RMA FORM 5
**Submission on publicly
 notified Proposed Porirua
 District Plan**

To: Porirua City Council

2. This is a **submission** on the **Proposed District Plan** for Porirua.

2. Eastern Porirua Residential Intensification Precinct (EPRIP)

Figure 1: 10 minute walk from Cannons Creek town centre to 111 Bedford St. Three possible routes.
Source: Google Maps

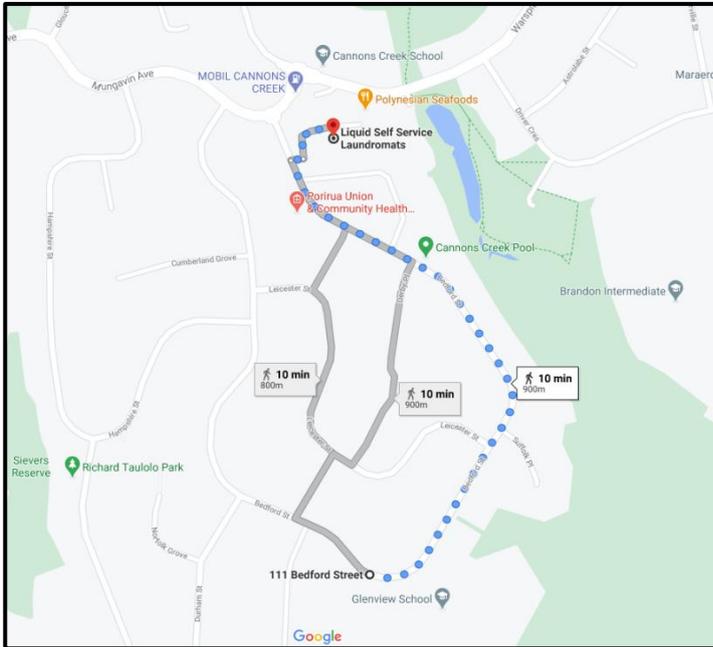
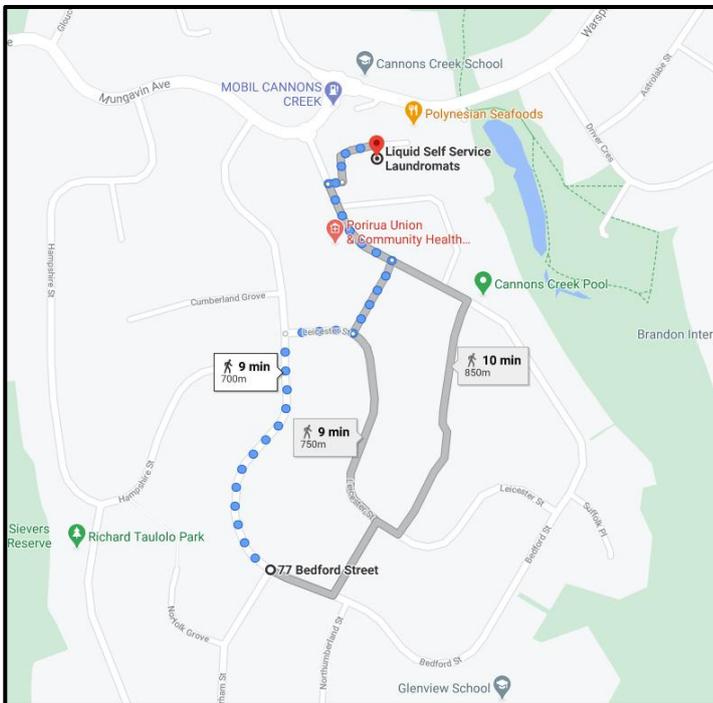
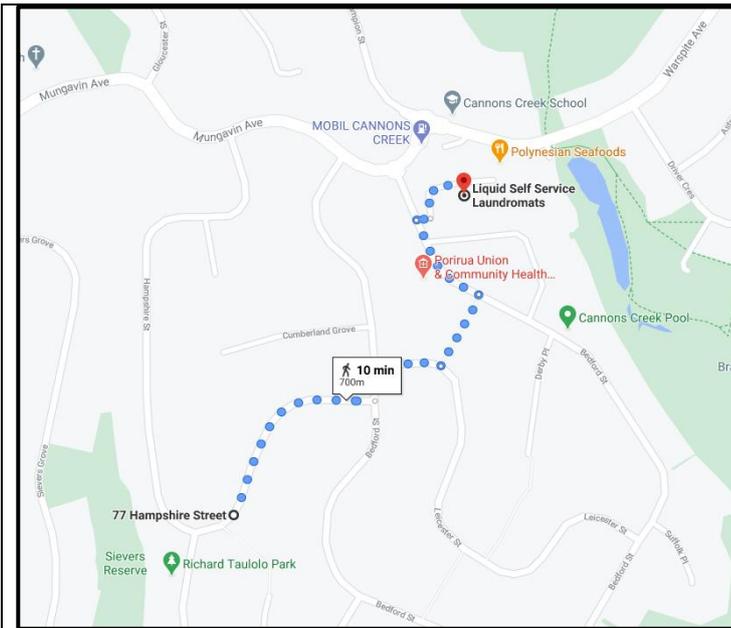
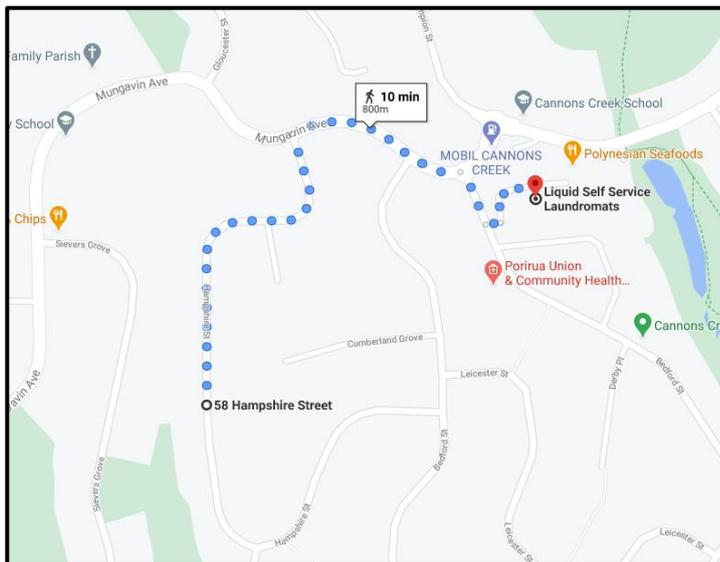
For example, UDTR Area F includes 195 – 231 Bedford St and 204 & 206 Mungavin Ave. This area borders a number of other properties on Mungavin Ave, Bedford St and Leicester St. However, as Figures 1 – 4 and the Pedestrian Shed Analysis Plans at Appendix 2 show, the entire block encompassed by Bedford St (Figures 1 & 2) and the vast majority of the block encompassed by Hampshire St is within 10 minutes' walk of the Cannons Creek Centre using a 5kmph walking speed. As such this entire area should be within the EPRIP.

Amend the EPRIP boundaries to better reflect the natural breakpoints such roads, parks and walkways to create more developable blocks and minimise the potential for adverse effects between different zones.

Figure 5: Southern portion of Bus route 226.

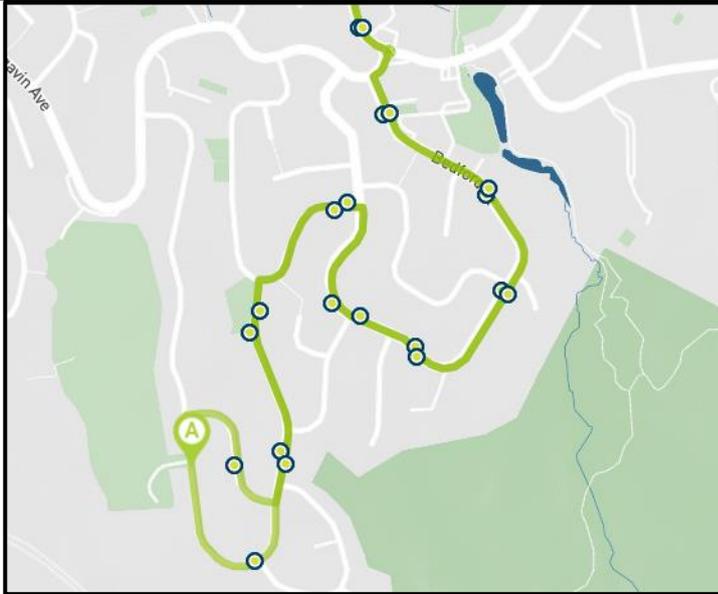
In addition to the ease with which someone can walk between these blocks and the Cannons Creek Centre there is the matter of public transport to consider. The No. 226 bus (<https://www.metlink.org.nz/timetables/bus/226>) provides a link between the Porirua CBD and Cannons Creek. It travels via Champion St, stops at the Cannons Creek Centre, before travelling south though Cannons Creek via Bedford St, Hampshire St and Servers Gr, before turning on Swansea St and travelling back along the same route. This bus completes the entire route 20 times per day with a further 10 trips completing part of the route. This equates to one trip every half hour.

This bus route improves the accessibility of the Bedford St, and Hampshire St blocks and as such supports the fact that these blocks should be included in the PERIP.

Include areas along the existing No. 226 Bus route in the EPRIP as this is an existing bus route where the frequency of the service can be increased as demand increases.

Figure 1: Marked up extract from Studio Pacific Architecture Drawing 2498/B.7/B

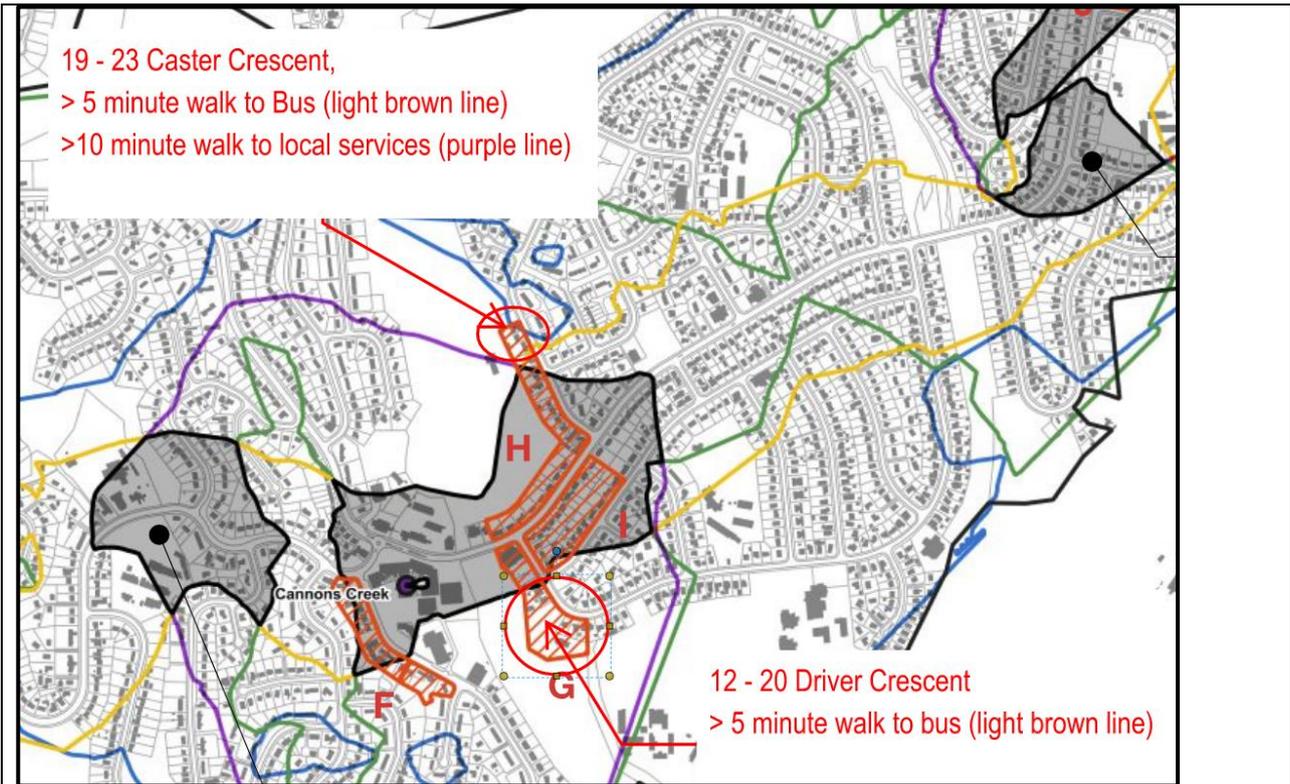
Area No.	Description	Discussion
1	Ten properties at the western end of Cumberland Grove.	All properties on the street are within a 9 minute walk/650m of the Cannons Creek Centre (two routes available). The western most GRZ property is just 70m or 1 minute walk from the furthest MDZ property. The area is surrounded by MDZ land so accessibility does not seem to be the issue. Topography is steeper than some in the area but not so much so that a medium density development cannot be built. Approx. half the

Some of the area identified for including in the EPRIP don't fit the UDTR criteria. For example, 19 – 23 Castor Cres have been identified as being with the EPRIP area H but are outside the 5 minute walk to a bus and the 10 minute walk to local services. 12 – 20 Driver Cres are outside the 5 minute walk to a bus stop. Presumably this area was included in EPRIP Area H because it made sense to group these properties together and have one block of land with the same zoning than have a small group of houses at the end of the group with a different zoning. This same approach should be taken to the above areas and they should be rezoned as noted in Table 1.

Amend the District Plan zoning as described in Table 1 above to that Areas 1, 2, 4 – 8 are zoned MDZ. Review the zoning of Area 3 and rezone suitable areas MDZ.

**Appendix A
Eastern Porirua Bus Routes**

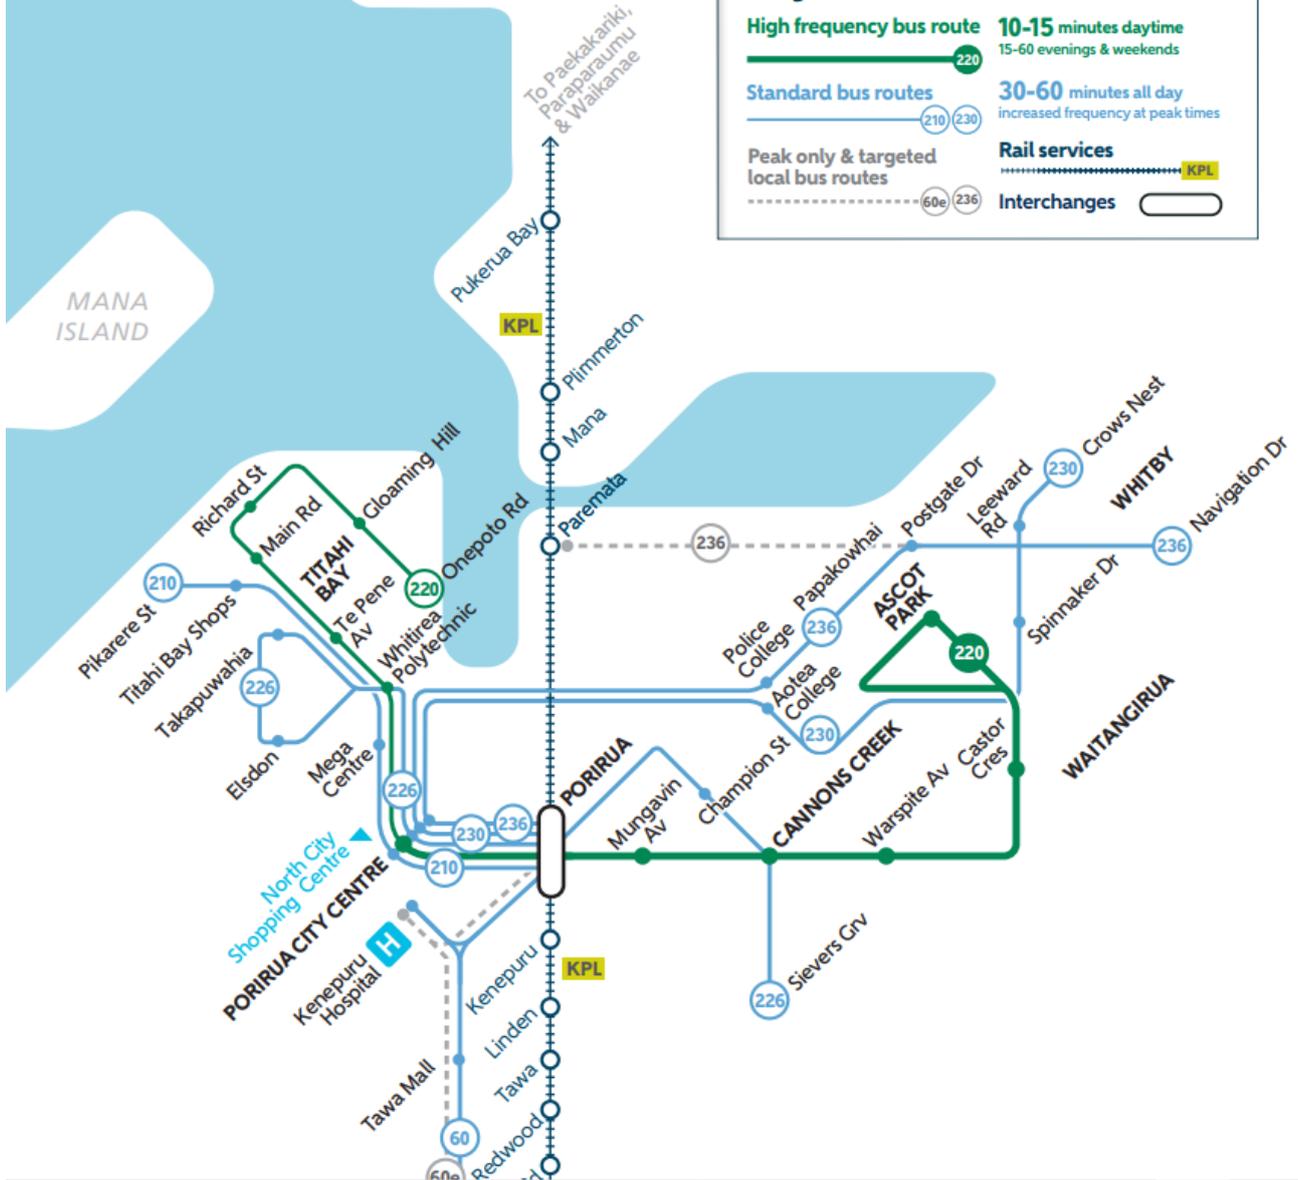
One of the factors considered in the UDTR is the Public Transport Pedestrian Shed, being a 250m/5 minute walk from a “high frequency” bus stop. The only bus route considered to be high frequency is the No. 220 bus as this has a 10-15 minute frequency during the day and a 15-60 minute frequency during the evenings and weekends.

The No. 226 bus provides a reliable frequent service and while this is not considered “high frequency” at present, additional development in proximity to this bus route will increase patronage and as a result in additional services being added. In effect creating a high frequency Bus Route. Additional development potential should be provided along this existing bus route.

Provide additional development potential via the EPRIP both where there is currently or where there could be, a high frequency bus route. Rather than just on the current high frequency bus route.

Appendix B Pedestrian Shed Analysis

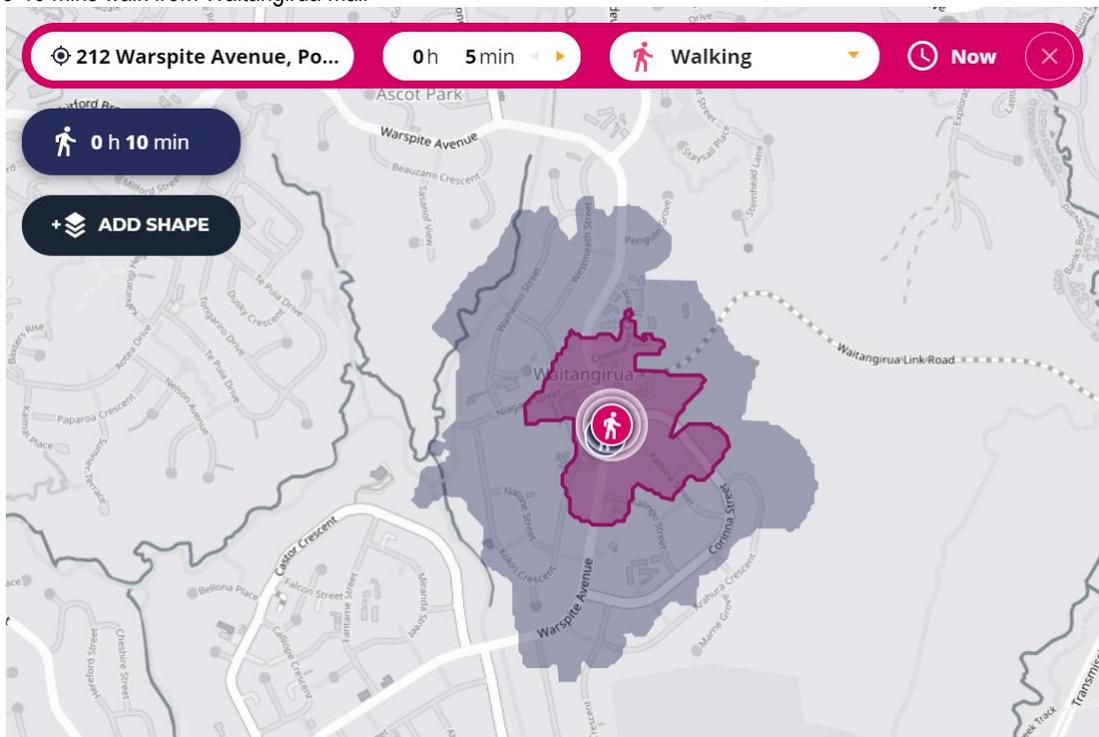
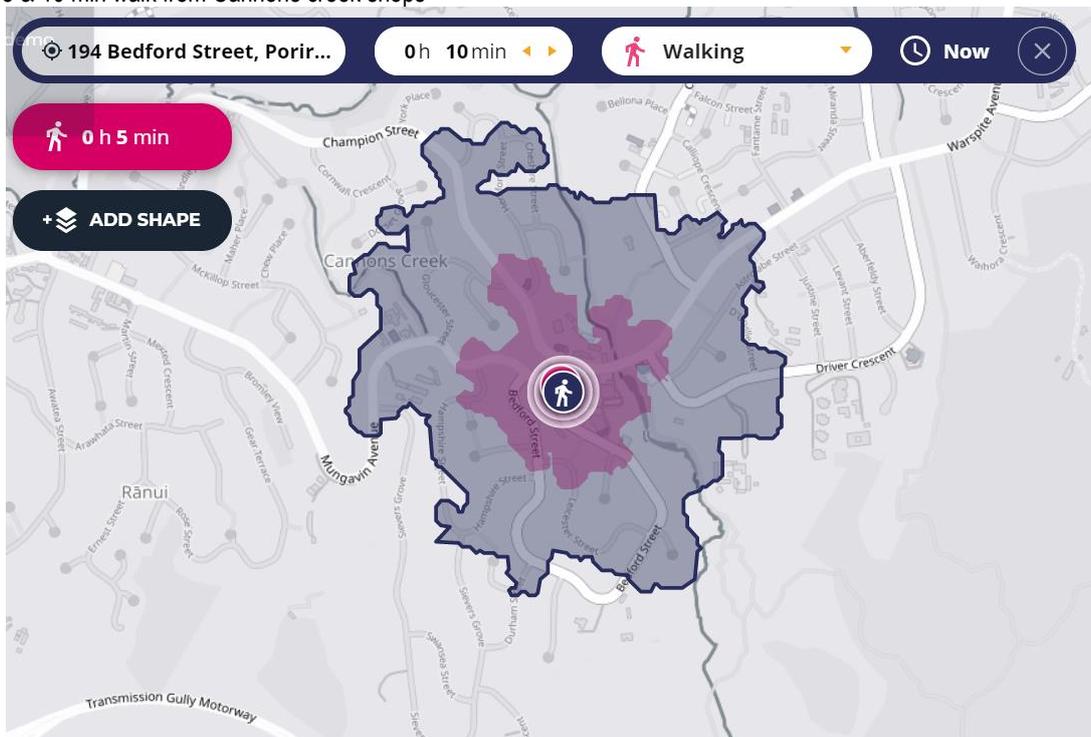
Based upon these factors a walking speed of 3 km/ph is very conservative and a more appropriate figure would be 5 km/ph. Using a 5 km/ph walking speed a significant number of additional areas come within the 5 and 10 minute walking distances specified in the EPRIP.

Using a more appropriate 5 km/hr walking speed and a 10 minute walking time places a significantly larger area of eastern Porirua within the area identified as being suitable for residential intensification under the UDTR.

Amend the EPRIP based upon a 5 km/ph walking speed and a 10 minute walking time to rail stations, bus routes (all routes not just high frequency routes), centres, open spaces and schools.
